ASEC Report ID : 71840
Name of the Project : Enclave at Parkway Village
Project Location : Union City
Weather : sunny
Departure Time : 10/03/2024 9:30
ASEC Technician Name : Aminullah Azimi

This report provides a reassessment of the footing excavations for Lot #46 and Lot #76. The assessment includes excavation dimensions, depth, cleanliness, and the results of soil testing using a hand auger, Dynamic Cone Penetrometer (ASTM STP-399), and general probing tests.

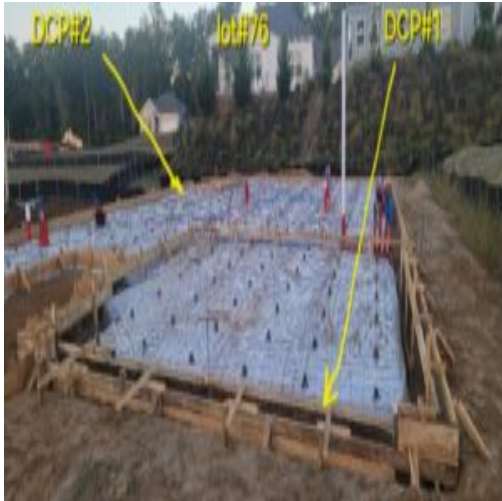
Note: a wall footing for Lot #76 exhibited soft soils. It was recommended that the contractor undercut 1 foot and replace with No. 57 stone, lean concrete or suitable material, location shown by yellow line,
